Item ID: D350-607-541 Accept ***N900040100*** Setup Start ***NS1***
 Revision ID: Stop ***NS2***
 Item Name: AS350/AS355 Quick Release Heli-Utility-Basket™ Long, Heavy Duty Lid
 Start Date: 11/10/2016 Start Qty: 1.00 ***1*** Cust Item ID:
 Required Date: 11/22/2016 Req'd Qty: 1.00 ***1*** Customer:
 Reference:

DART SERVICE INSTRUCTION

TO AMEND INSTALLATION INSTRUCTIONS D350-607-3 Rev.D,
INSTALLATION INSTRUCTIONS D350-607-4 Rev. C AND
INSTRUCTIONS FOR CONTINUED AIRWORTHINESS ICA-D350-607 REV. 6
REF TCCA STC: SH94-14
REF FAA STC: SR00213NY
REF EASA STC: EASA.10016996
REF BRAZILIAN STC: 2007S03-03/-04/-05/-06

FIGURE 1: INSTALLATION OF D4775-041 FWD STRUT

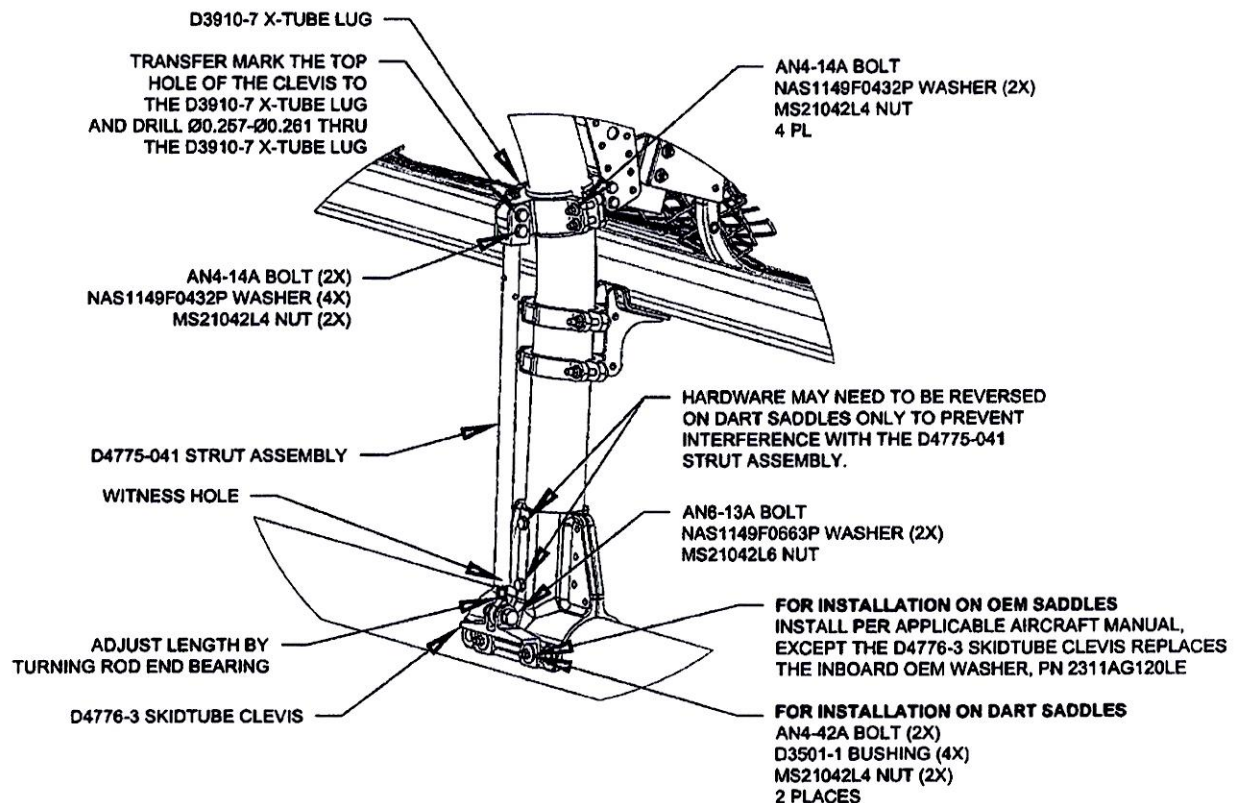
3.1 Substitute the Forward Lower D3910-5 X-Tube Lug with the D3910-7 X-Tube Lug as shown in Figure 1.

3.2 Install the forward D4775-041 Strut Assembly. Transfer mark from the upper hole on the clevis of the D4775-041 Strut Assembly to the D3910-7 X-tube Lug and drill thru the lug $\varnothing 0.257$ - $\varnothing 0.261$ as shown in Figure 1. Touch up chemical conversion coating per MIL-DTL-5541. Check the witness holes located at the bottom end of the D4775-041 Strut Assemblies to ensure that the thread from the rod end extends past the witness hole.
Torque MS21042L4/-4 nuts to 50-70 in-lbs (5.7-7.9 N-m). Torque MS21042L6/-6 nuts to 160-190 in-lbs (18.1-21.5 N-m).
